FOR APPROVAL OF THE FOYNES TO LIMERICK ROAD (INCLUDING
ADARE BYPASS) COMPRISING:

ORAL HEARING

Brief of Evidence

Noise and Vibration

Plate 3.6 of the EIAR - Refined Route Corridor Options 1-4

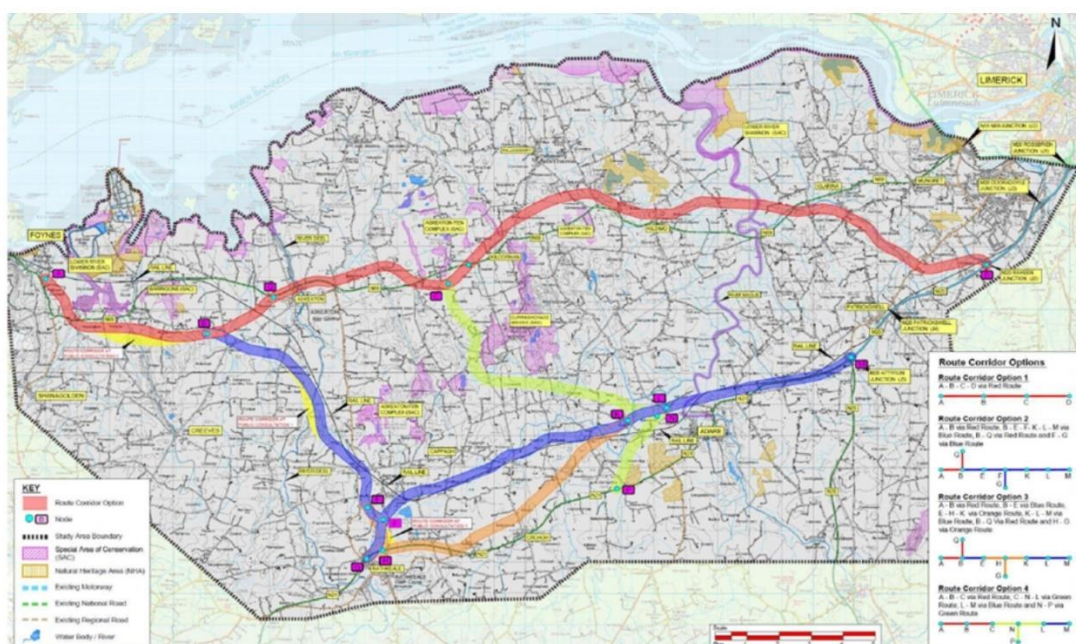
4.2.6 Submission ENV-25 states as follows with respect to the further analysis undertaken to compare the divergent sections between Node E and Node K “..As I understand dwellings along Option 3 were only considered for additional noise impact above the current levels experienced from the current N21 whereas dwellings on the more remote Option 2 were assessed based on full noise impact”

4.2.7 In response, the methodology set out in Page 6/63 of the Route Selection Report (Volume 1), confirms that properties along the full extent of Option 3 and Option 2 were reviewed and included in the assessment as part of the initial exercise.

- 4.2.8 In order to compare potential noise impacts associated with both route options, a review of traffic flows between the Do Nothing and Do Something scenarios was undertaken. This review indicated that noise level changes of less than 1dB would be experienced along the existing N21 as part of Option 3 and would result in a negligible change in noise levels at properties along this section of road. In addition, a further assessment of the likely requirement for noise mitigation between the two route options over the full extent of the study area was undertaken. The assessment concluded that noise impacts along Option 2 (blue) were greater compared to Option 3 (orange) in terms of changes to the noise environment and the requirement for noise mitigation. On the basis of this further analysis, Option 3 remained a preferred option over Option 2.

<table><tr><td>Designed: JH</td><td>File:</td><td>Status: E.I.A.R.</td></tr><tr><td>Checked: GR</td><td>Scale: 1:5000 (@ A3)</td><td>Drawing No: Fig 12.7</td></tr></table>

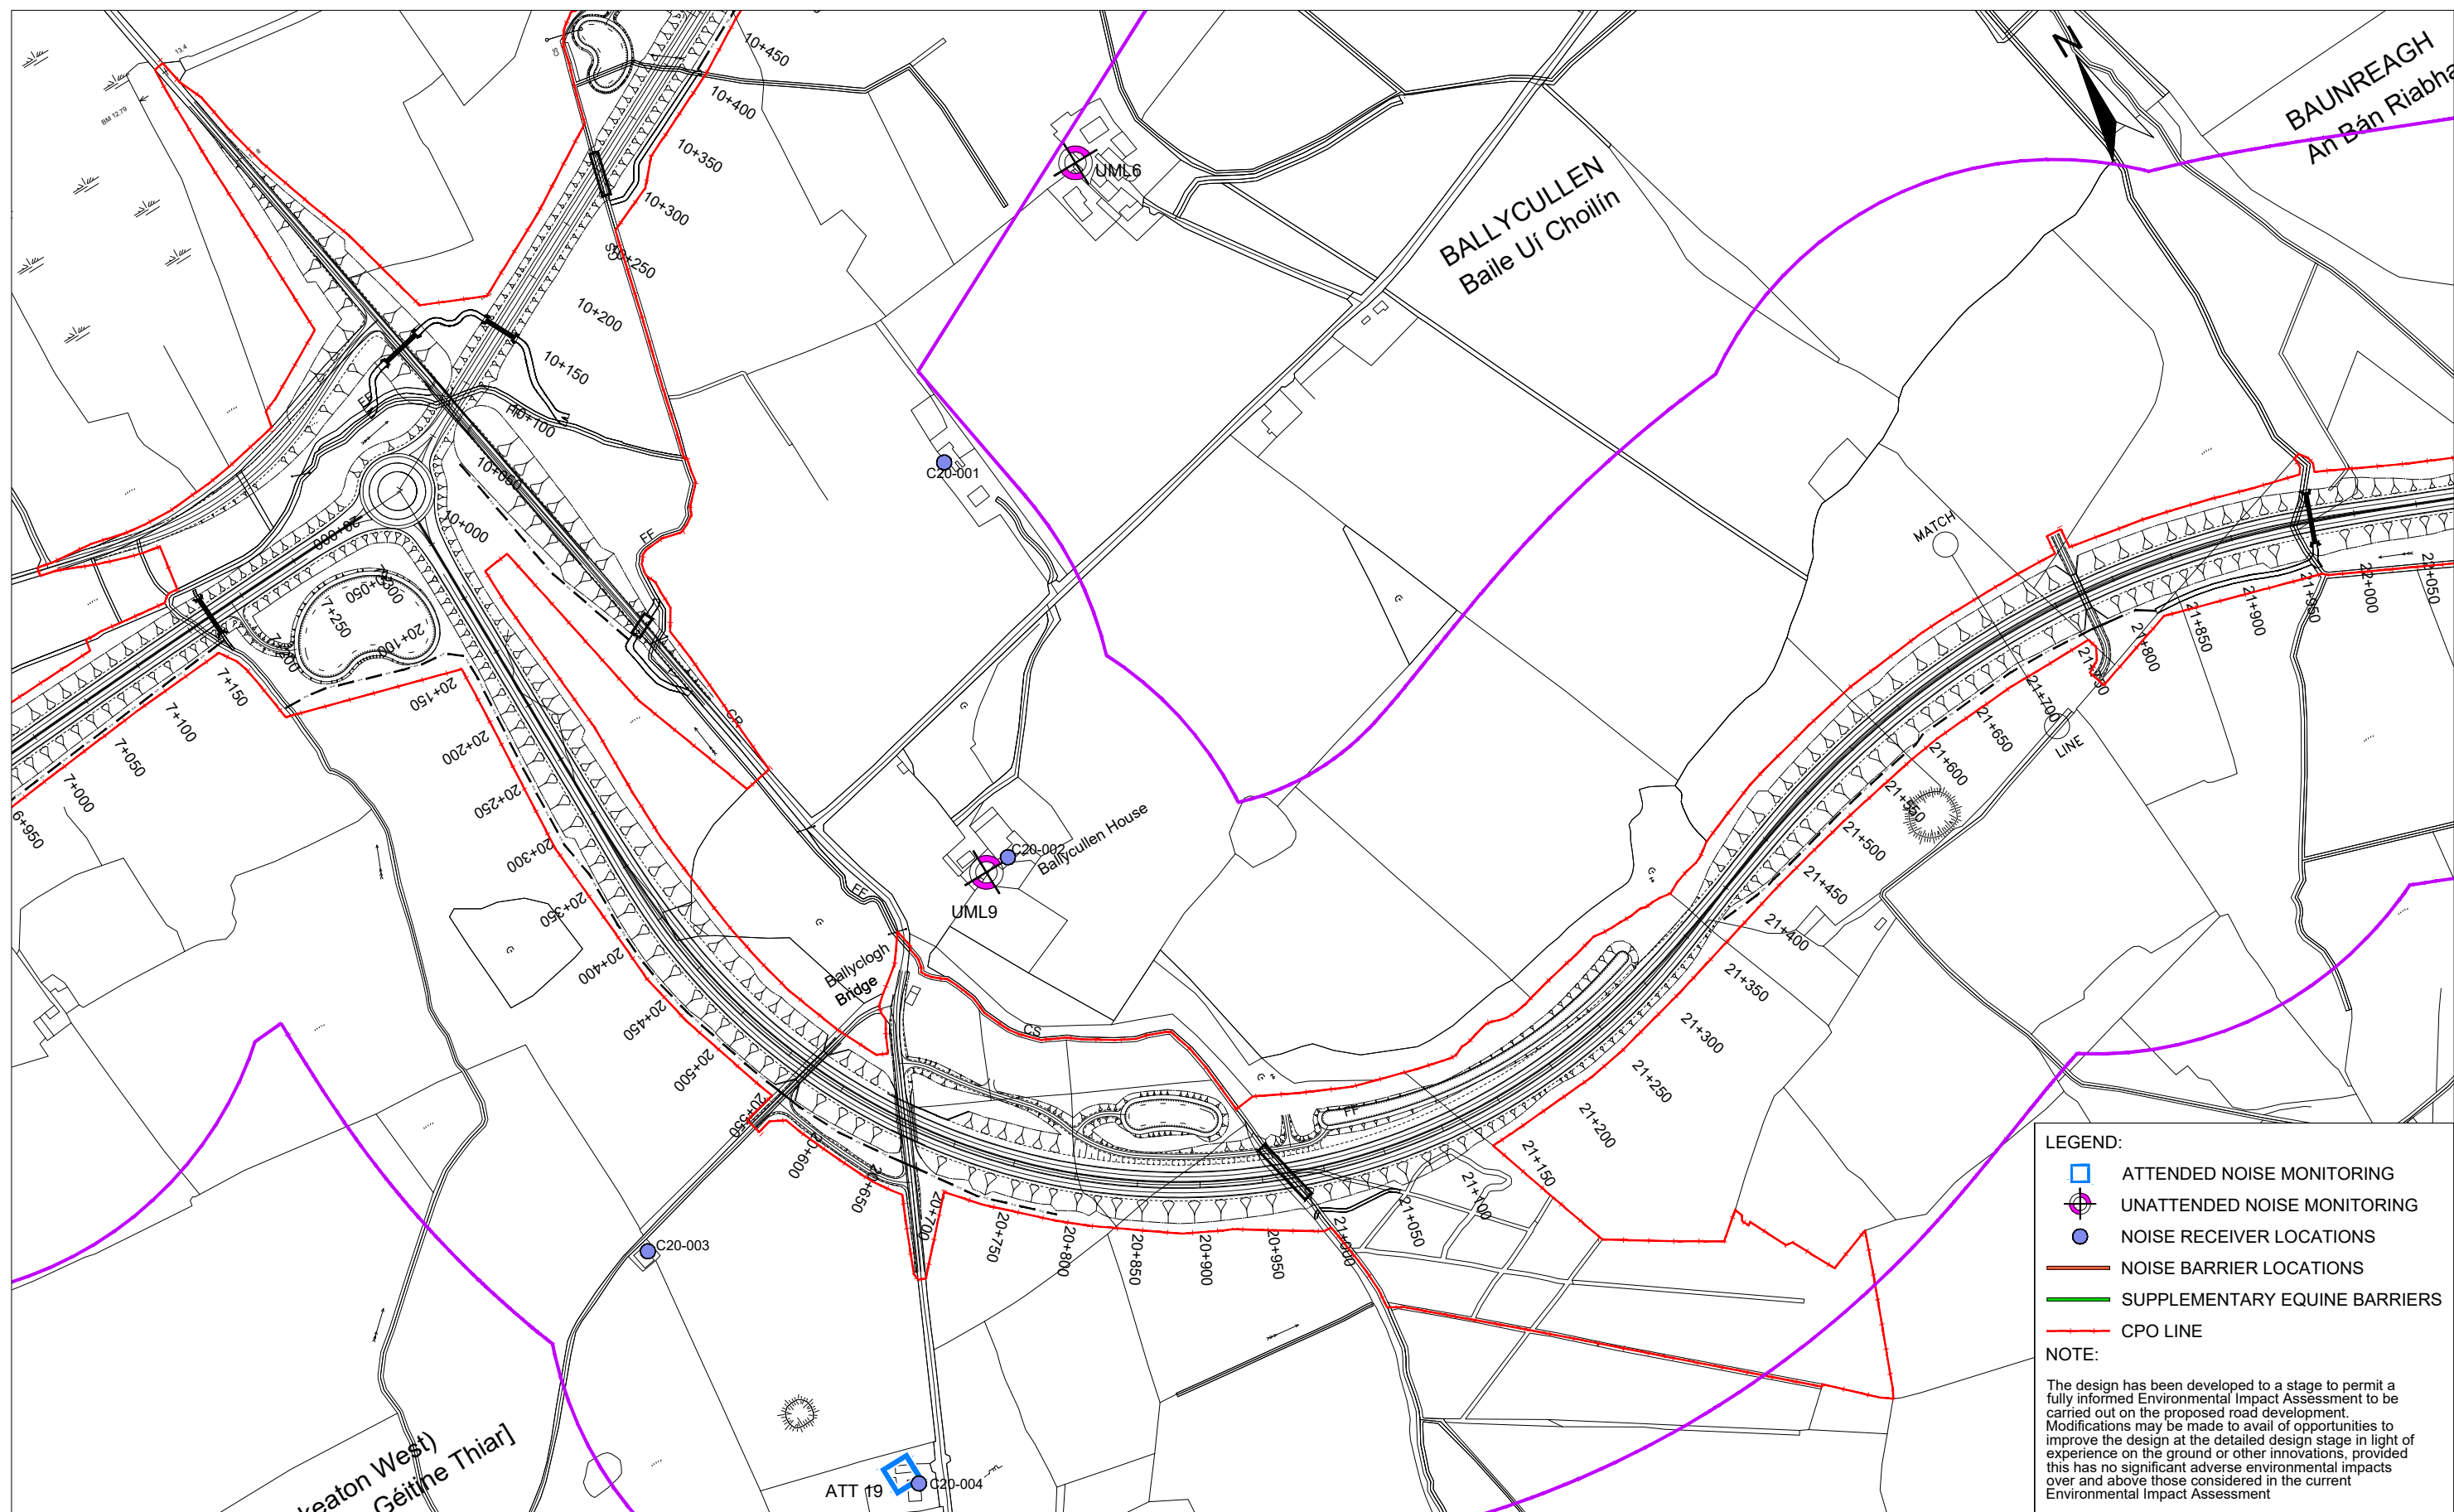
- Submission SCH-64: This submission refers to the property number C20-001 located east of the project within Ballycullen. The modelled location is illustrated in Figure 12.7. The operational noise levels associated with this property is 53 dB L_{den} (Included in EIAR Appendix 12.1) which is below the operational traffic noise design goal.

<table><tr><td>Designed: JH</td><td>File:</td><td>Status: E.I.A.R.</td></tr><tr><td>Checked: GR</td><td>Scale: 1:5000 (@ A3)</td><td>Drawing No: Fig 12.9</td></tr></table>

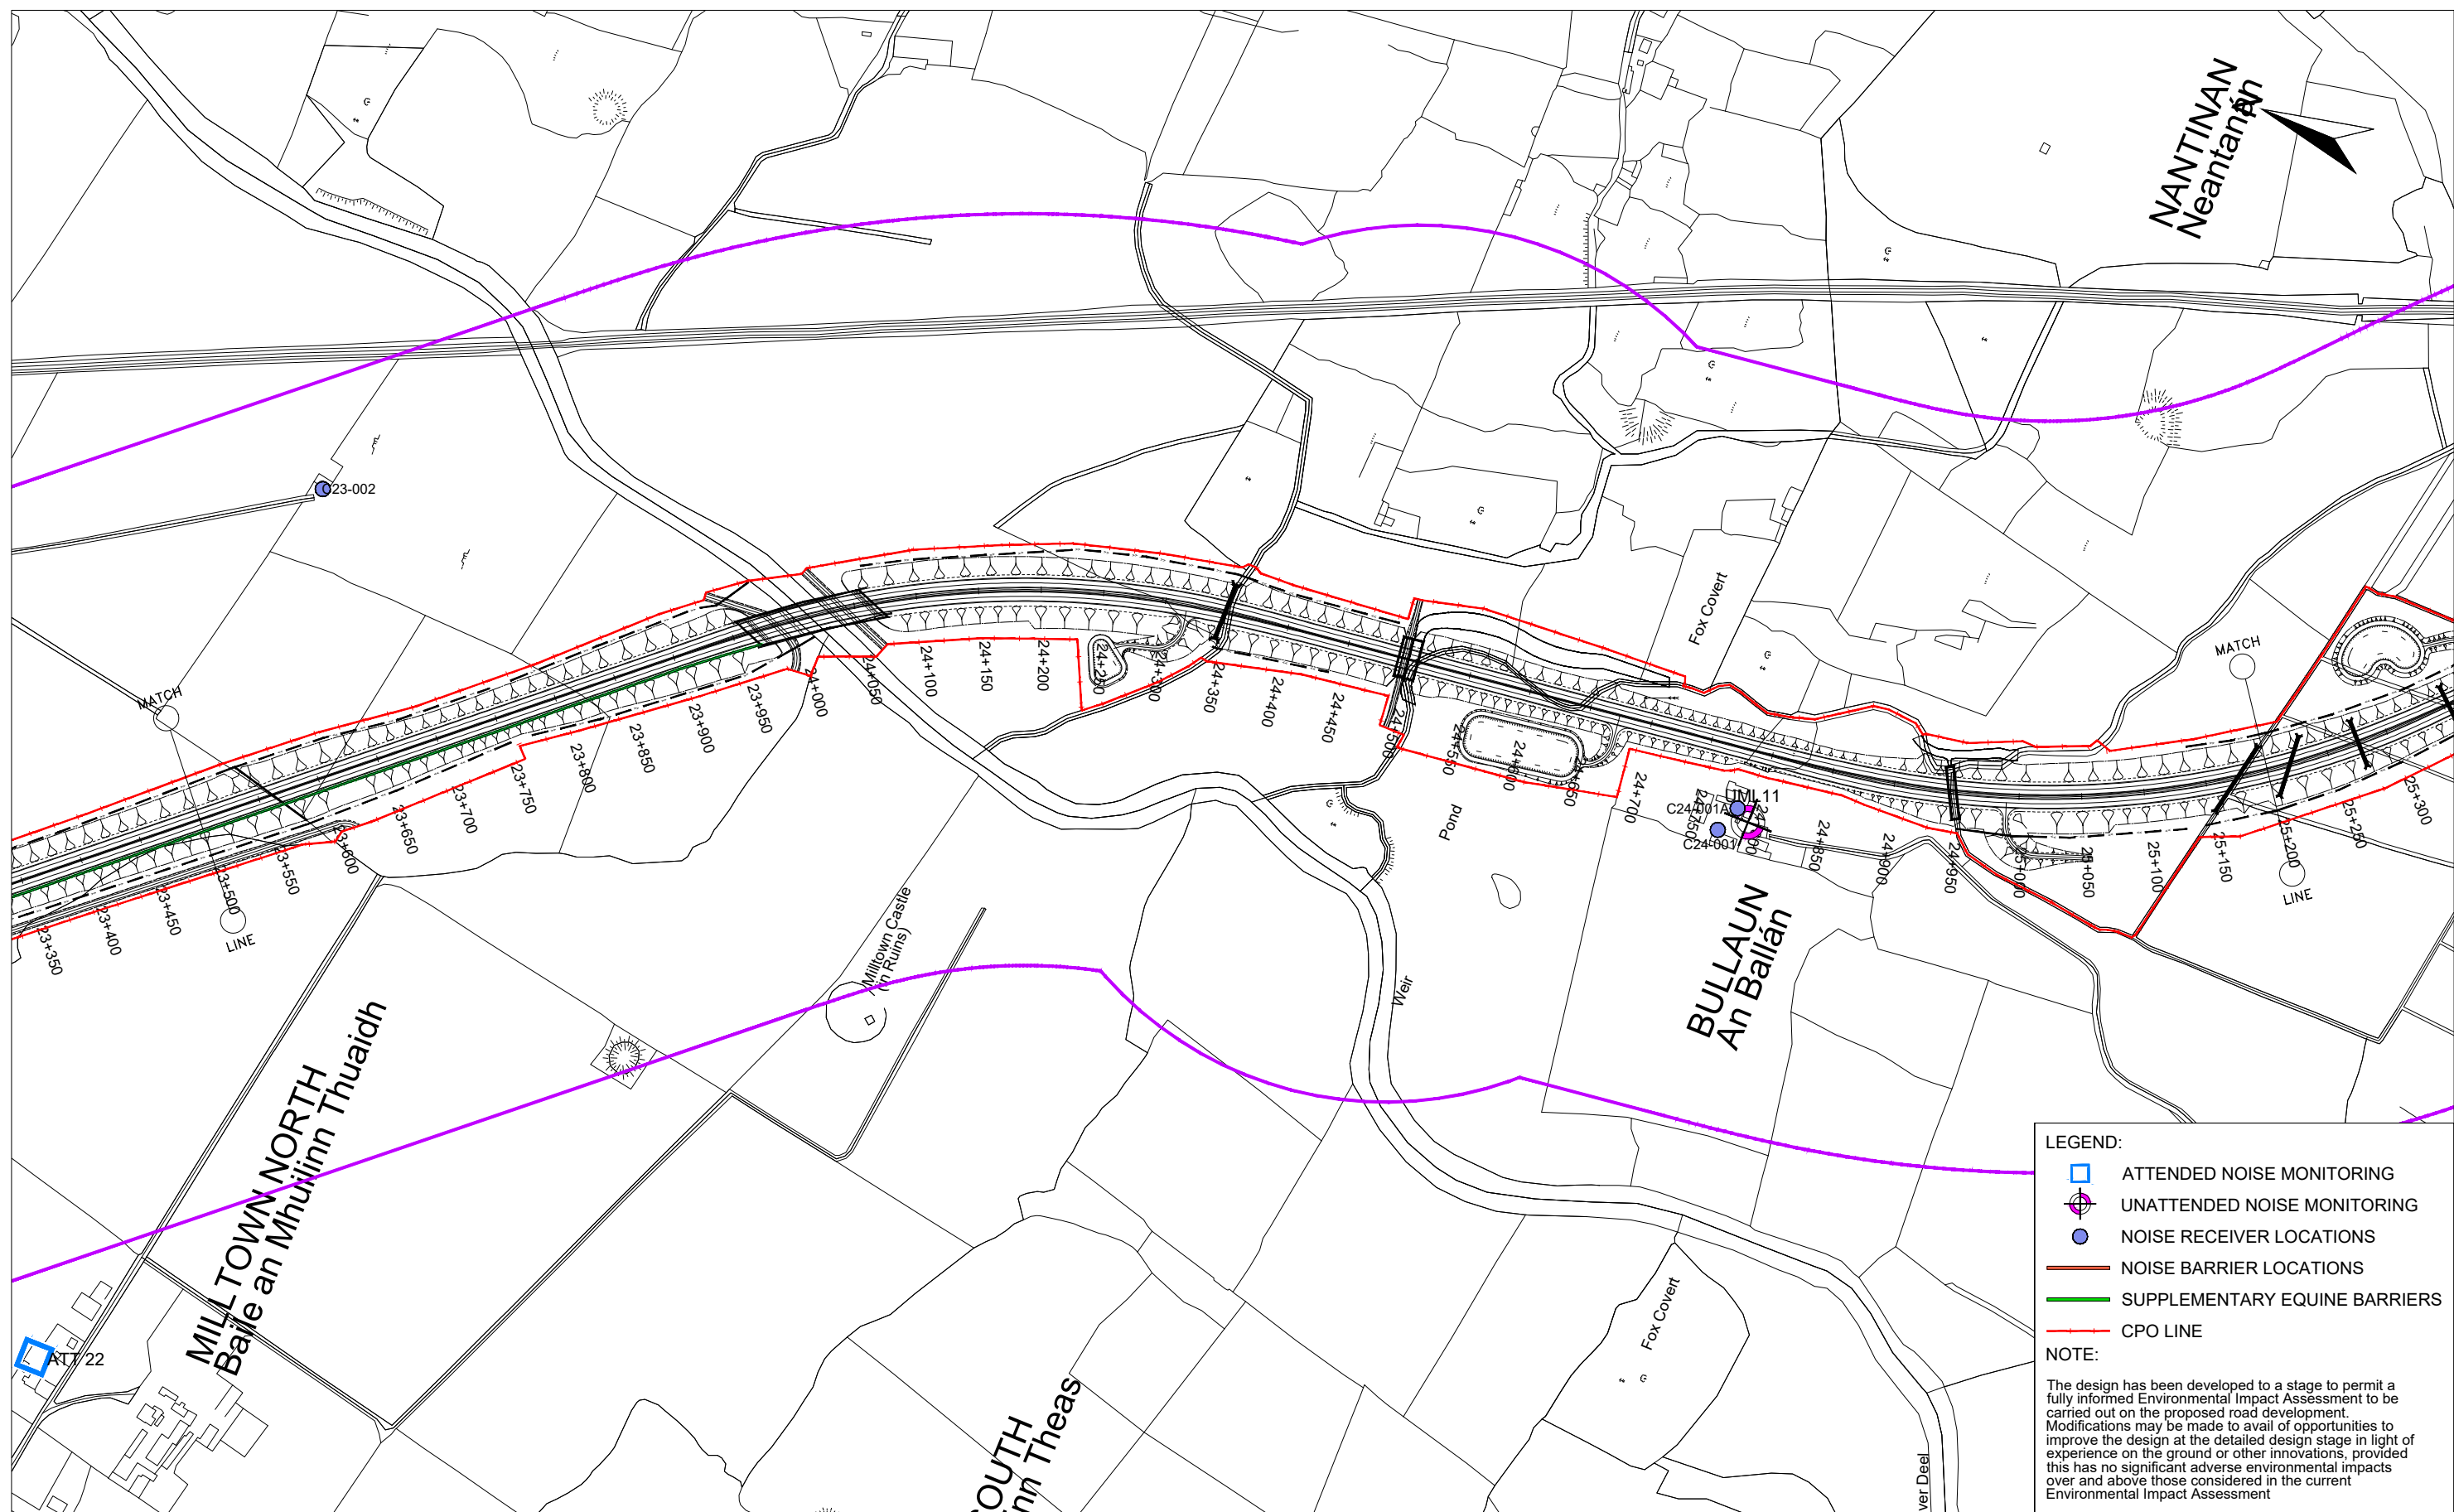
- Submission SCH-66: This submission refers to the property number C24-001 and C24-00A located west of the project within Bullaun. The modelled locations are illustrated in Figure 12.9. The operational noise levels associated with these properties are 54 and 58dB L_{den} respectively (Included in EIAR Appendix 12.1) which are below the operational traffic noise design goal. Additional noise mitigation is therefore not required at this location.
